UNITED STATES
NUCLEAR REGULATORY COMMISSION
WASHINGTON, D.C. 20555-0001

SUBJECT: DAVIS-BESSE NUCLEAR POWER STATION, UNIT 1 – STAFF ASSESSMENT
OF RESPONSE TO 10 CFR 50.54(f) INFORMATION REQUEST – FLOOD-
CAUSING MECHANISM REEVALUATION (CAC NO. MF3721)

STAFF ASSESSMENT BY THE OFFICE OF NUCLEAR REACTOR REGULATION

DAVIS-BESSE NUCLEAR POWER STATION, UNIT 1

Figure 3.2-1. Davis-Besse topographic elevations depicted in the LIP computer model prepared using FLO-2D Pro (as revised). Elevations reported are NAVD88.

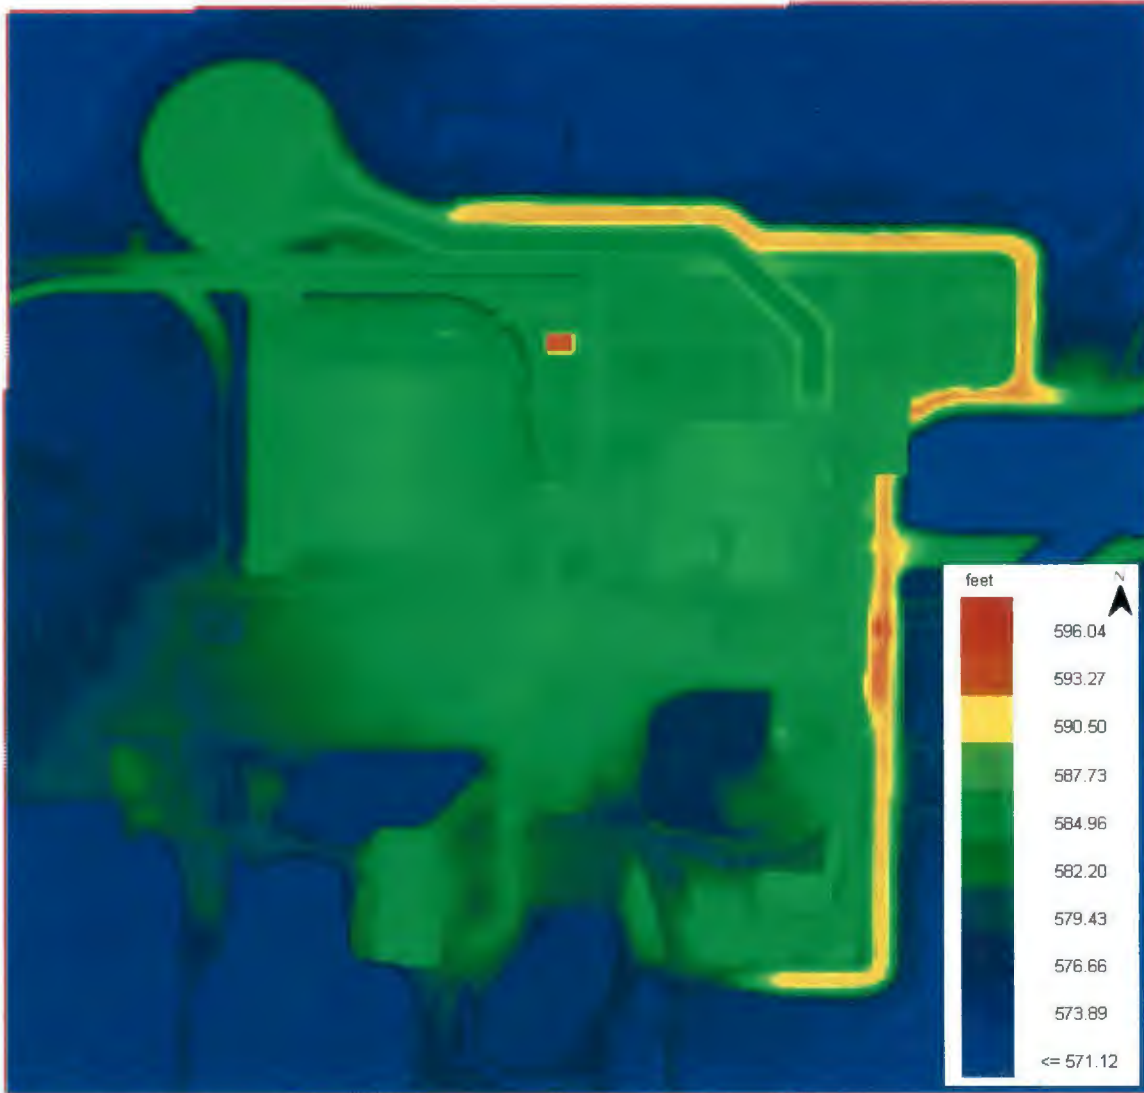
The licensee reevaluated the flood hazard resulting from LIP due to a thunderstorm over an immediate drainage area of about 0.3 mi² (0.8 km²) that included the footprint of the Davis-Besse powerblock, the site's vehicle barrier system (VBS), and all contiguous natural drainage areas in the 1.49 mi² (3.86 km²) controlled area. The licensee reevaluated the flood hazard due to LIP using a digital terrain model (DTM) to approximate the topographic ground surface corresponding to the reactor site and environs. Because the finished grade of the powerblock is elevated relative to the surrounding topography, the licensee generally did not include lower-elevation areas in its computational model as meteoric water would be expected to drain off-site via gravity as suggested by the results of the computer simulation shown on Figure 3.2-1.

The staff reviewed the licensee's approach to the development of the computation grid for the FLO-2D model against relevant regulatory criteria based on present day methodologies and regulatory guidance. The staff considers that the approach described by the licensee is reasonable.

Figure 3.3-1. Basins defining the Toussaint River watershed. Star designates the Davis-Besse site. Taken from FENOC (2015b).

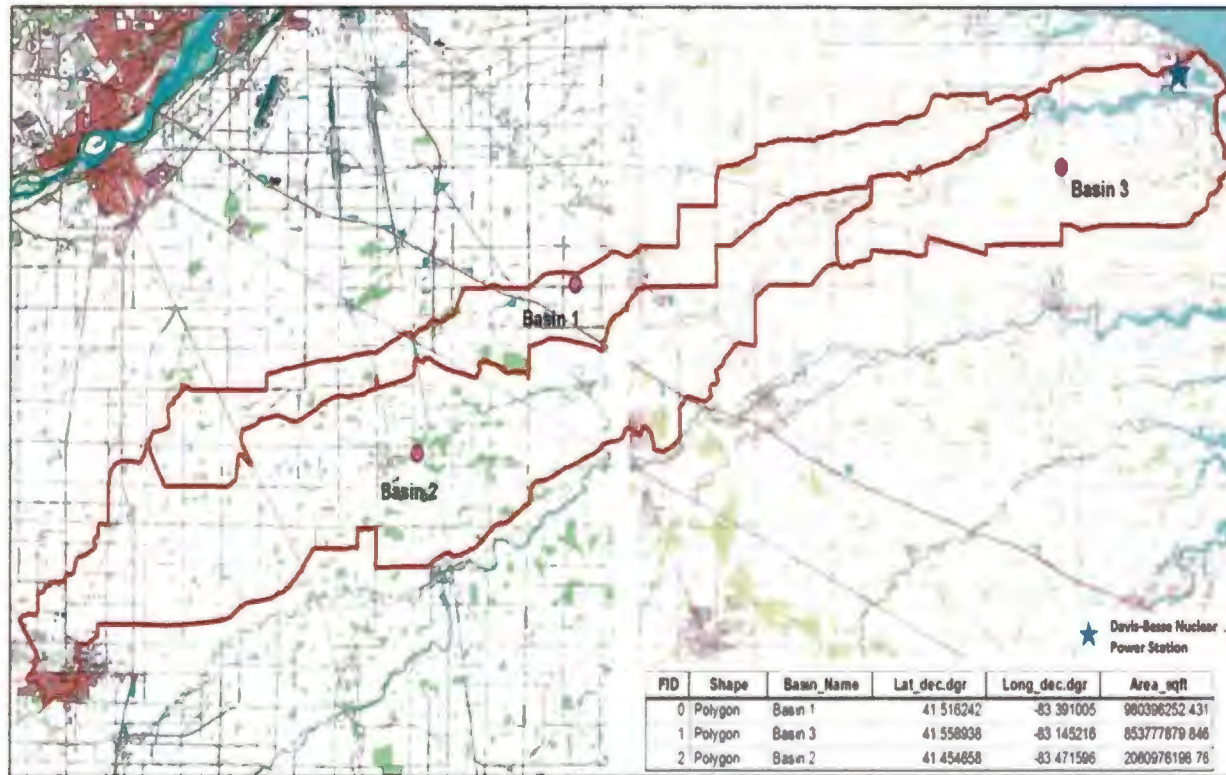
River and its attendant watershed are ungauged, so the licensee alternatively prepared a synthetic hydrograph in connection with the rainfall-to-runoff transformation using the Synder method (1938). To conservatively represent the extreme events being modeled, the estimated peak discharge was increased by one-fifth, as suggested in NUREG/CR-7046. The HEC-HMS calculation was limited to Basin 3 of the Toussaint River watershed (Figure 3.3-1) as that portion of the basin is contiguous with the Davis-Besse site.

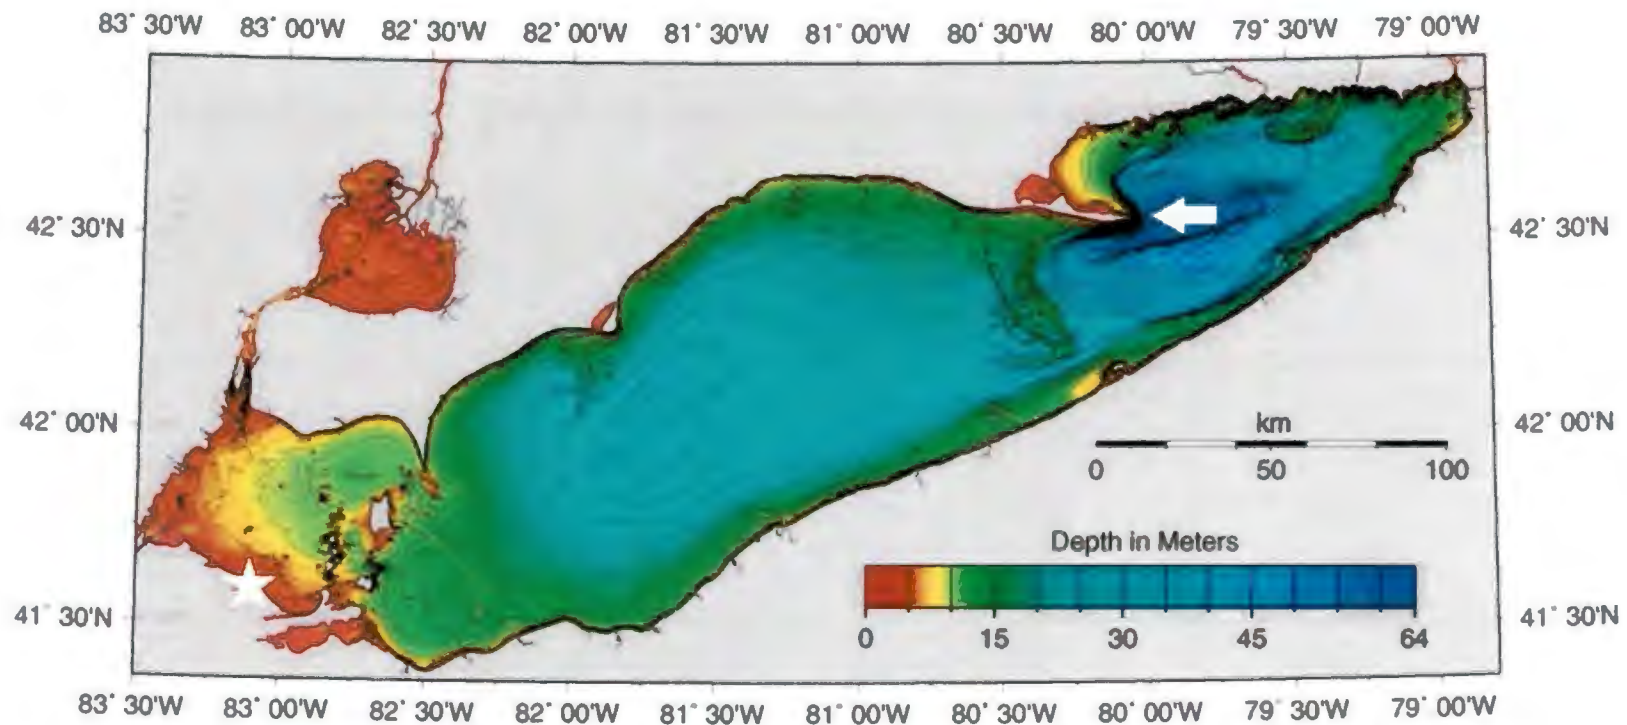
formation of tsunami-like waves when bluff material is eroded has not been mentioned. The staff conducted an independent modeling study to examine how a hypothetical tsunami generated in response to a submarine landslide occurring within Lake Erie might affect flood elevation levels at the Davis-Besse site. Based on the relatively low topographic relief along the western shores of Lake Erie, the staff identified the location of the controlling landslide source and used the COULWAVE (Cornell University Long and Intermediate Wave Modeling Package) computer program (Lynett and Liu, 2002) for the water-level analysis portion of the confirmatory tsunami simulation. The simulation produced a probable maximum tsunami WSE of 573.7 ft (174.9 m) IGLD55 in Lake Erie, 10.3 ft (3.1 m) below the site grade for the reactor complex of 584 ft (178.0 m) IGLD55. As a result, the staff concluded that tsunami-induced flooding does not impact the CDB at the Davis-Besse site.
